1 Purpose of Document

This document summarizes the changes between the previous ASI4U silicon revision C and the current silicon revision E. These include requested UART design changes. The purpose of the redesign was to correct reported timing errors by the UART in the following modes: Master, Monitor, and Repeater. A problem with slave communication in special network constellations was also fixed.

Figure 2.1 Comparison of Valid MAN-Code Signal to Faulty MAN-Code Signal

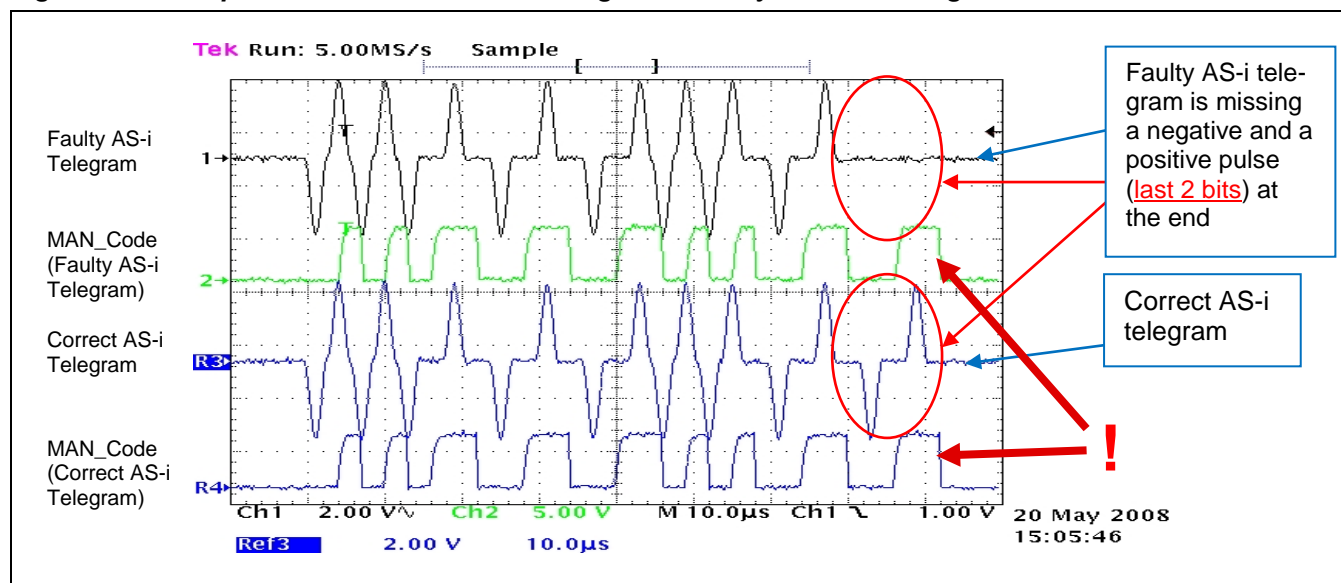
If the ASI4U revision C operates in Master Mode, Monitor Mode or Repeater Mode, the error signaling for an *End_Bit_Error* does not work correctly. In some special cases, the generated MAN-Code of a signal with an *End_Bit_Error* looks similar to the MAN-Code of a signal without any errors as demonstrated in Figure 2.1.

This malfunction of the ASI4U revision C results in an MAN-coded output signal that does not allow distinction between correct AS-I pulse sequences and pulse sequences that are shortened (missing one negative and one positive pulse). It occurs only under the following conditions:

- The parity of the signal is even.
- The last bit of the corrupt telegram is equal to binary 1.
- The *Stop_Bit* and the *Parity_Bit* or the *Start_Bit* and the *Control_Bit* are missing.
- If the *Start_Bit* and the *Control_Bit* are missing, the first pulse must have a negative polarity.

1. The last pulse of the MAN-coded LED1 output signal is now always kept in ACTIVE state for 9μs if an ASI telegram with an *Endbit_error* is received.

The polarity of the ACTIVE State depends on the signal setting at the DI ports in Master Mode, Monitor Mode, and Repeater Mode. If DI2 and DI3 are driven by equal input signals, the MAN output signal at LED1 is configured ACTIVE LOW. If DI2 and DI3 are driven by unequal input signals, LED1 becomes inverted and is configured ACTIVE HIGH.

Since a 9μs-wide MAN pulse is an out-of-specification event for the AS-I MAN signal, it will allow the connected microcontroller to recognize the error in the AS-I pulse signal on the AS-I line.

Figure 3.1 Test for ASI4U Revision C Error in Master Pause Detection

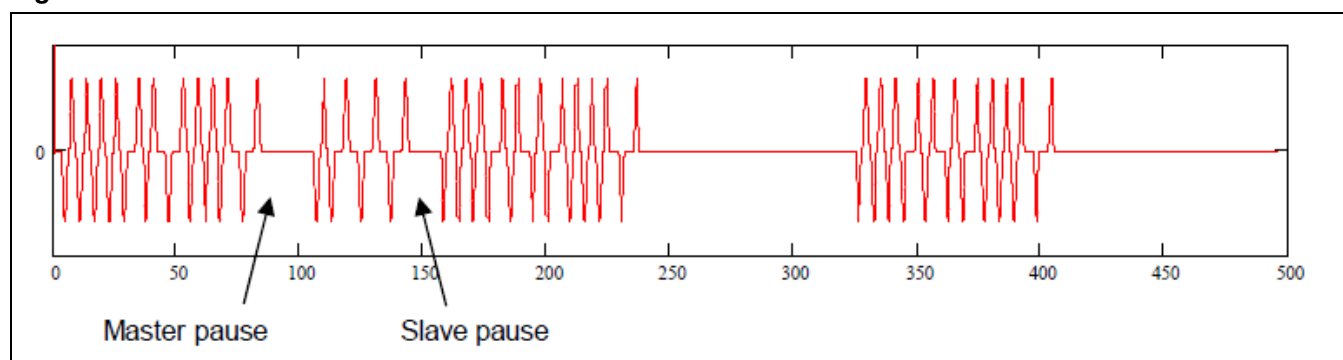
If the previous ASI4U revision C is operated in Slave Mode, the UART Master Pause detection does not always function correctly when the UART must listen to slave responses from a different slave. Depending on the actual AS-I line pulse timing, a slave response from a different slave is sometimes not recognized correctly, which results in a UART communication error. This prevents the Slave from understanding the next Master telegram correctly. If the Master telegram addresses the Slave itself, the error leads to a missing slave response and the Slave replies on a second repetition of the Master Call to its own address in asynchronous mode.

Figure 3.1 shows a telegram test case to reproduce the error. The AS-I signals shown in Figure 3.1 were generated by a signal generator that allowed sweeping the Master Pause and Slave Pause duration over the allowed specification limit. The first Master Call contains a different slave address than the tested slave. The second and third master calls address the tested slave. The tested slave replied with the erroneous behavior for certain Master pause and Slave pause scenarios only. The majority of the test cases were passed without error.

A new principle of AS-i telegram pause detection was implemented in ASI4U silicon revision E that is more precise and able to cover all valid timing scenarios for Master and Slave pauses. The new principle is now independent of the internal timing constraints of the UART state machine.
